* SUITE 307 * (INVENTORY SUITE)

SUITES 307 - NOYAC BAY (inventory suite)

■ Royal Pine Homes ■ 25 Baker Hill Blvd - Stauffville, ON ■ Apr 04, 2018

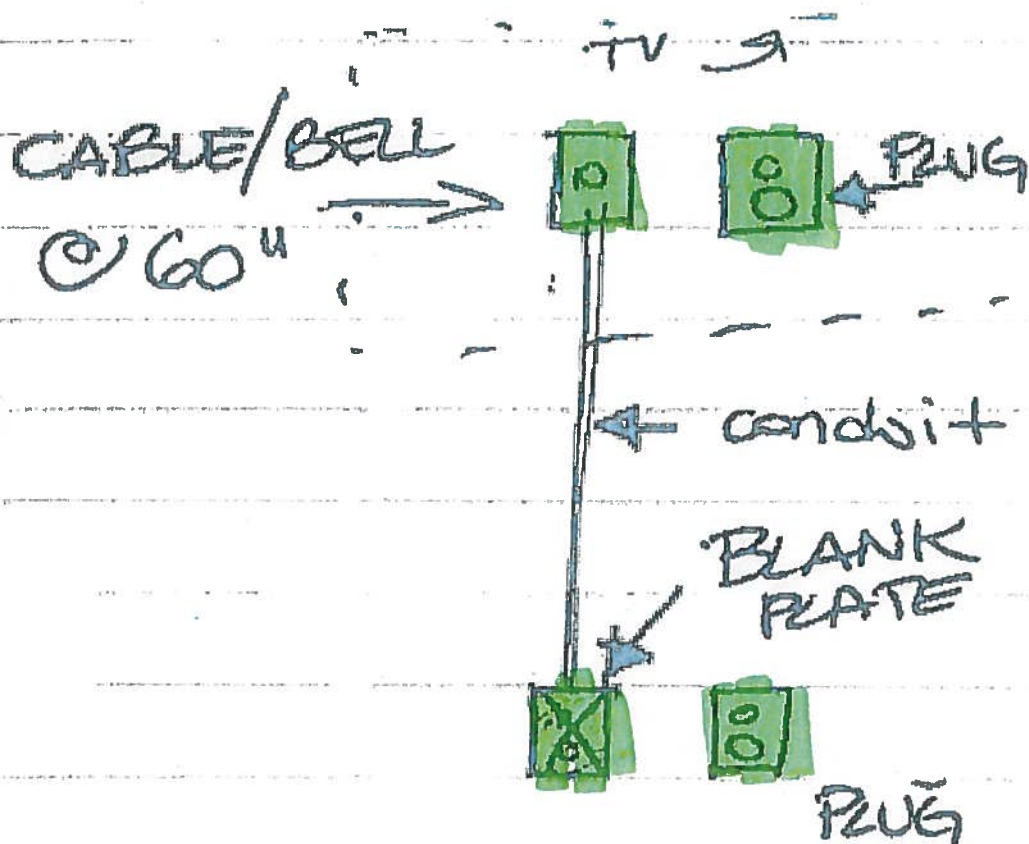
→ CONDUIT:

* KITCHEN *

- STD KITCHEN
- 1ST UPGRADE APPLIANCE PKG x 36" FRIDGE + CHIMNEY HOOD FAN + MICRO DRAWER
- (x2) = PENDANT LIGHTS
- (x5) = PUCK LIGHTS
- (x1) = PENINSULA PLUG
- 65" CHIMNEY HOOD center
- 129" SINK PIPE center
- Powder Room + ENSUITE RAISED VANITIES 36 1/4" (+ 3" SPLASH

NEW PLAN

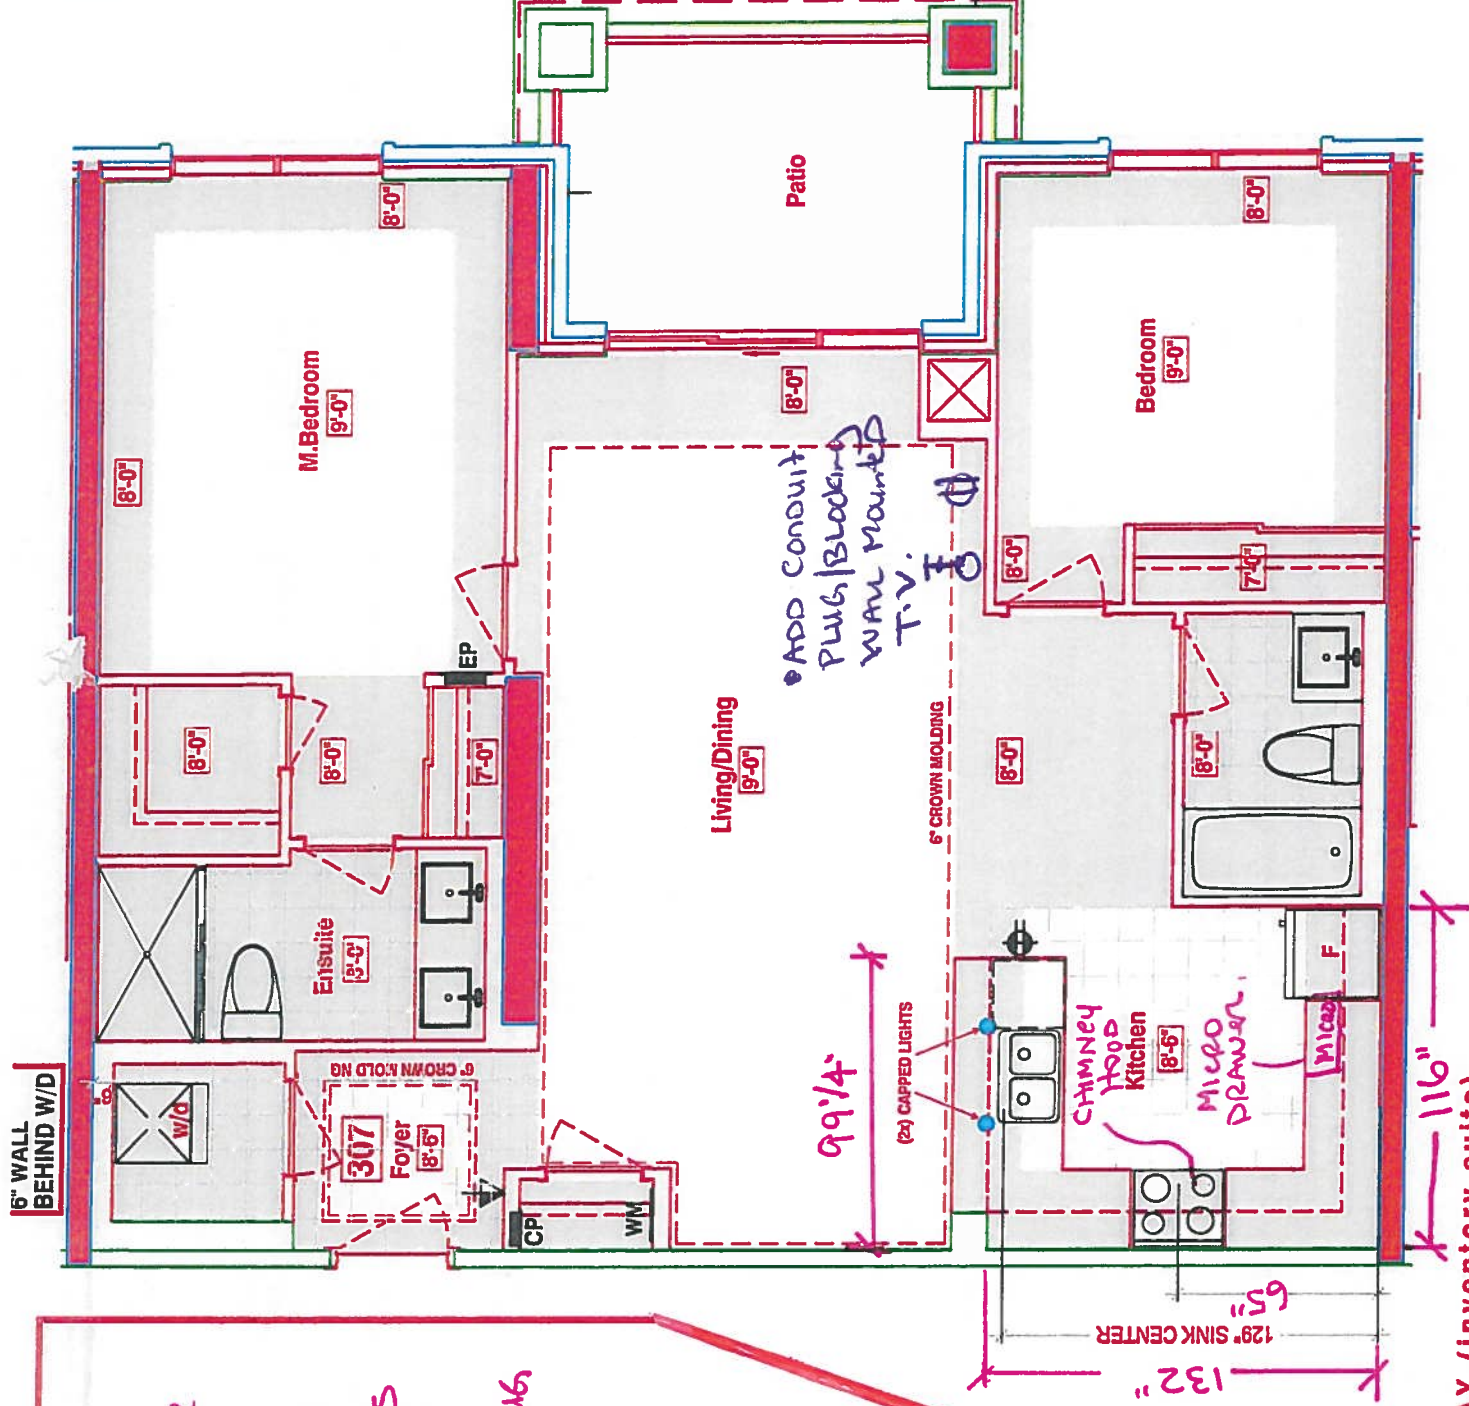
- REMOVED DEN
- REVISED KITCHEN

* REVISED LAUNDRY DOOR SWING & ENSUITE WALL AS PER THIS BROCHURE

CONDUIT / PLUG / BLOCKING
WALL MOUNTED
T.V.

STND KITCHEN LAYOUT

- Upgrade #1 appliance pkg
- 36" fridge + Chimney hood + microwave drawer (spec needed)
- x2 pendant light
- x5 puck lights
- x1 peninsula plug

*Powder Room +
ENSUITE RAISED
VANITIES (N/C)
w/ 3" splash

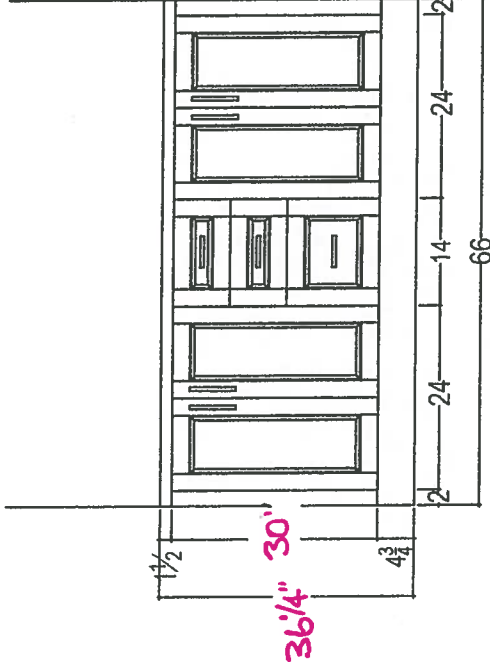
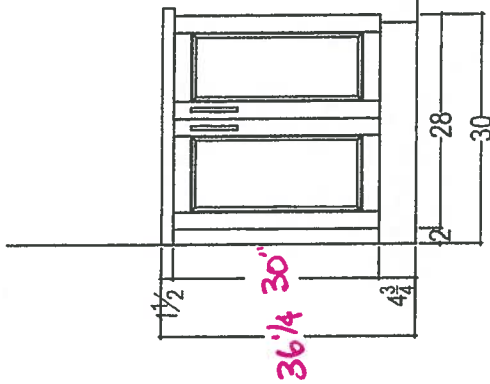
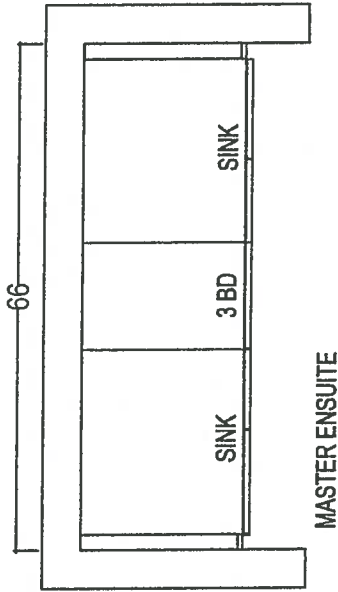
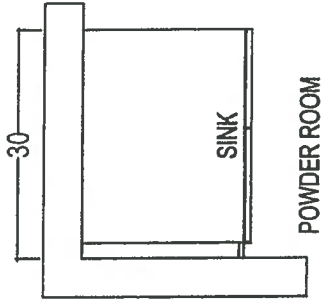
* RASIO VANITIES AS PER FONZE NO CHARGE
XU 3" SPLASH
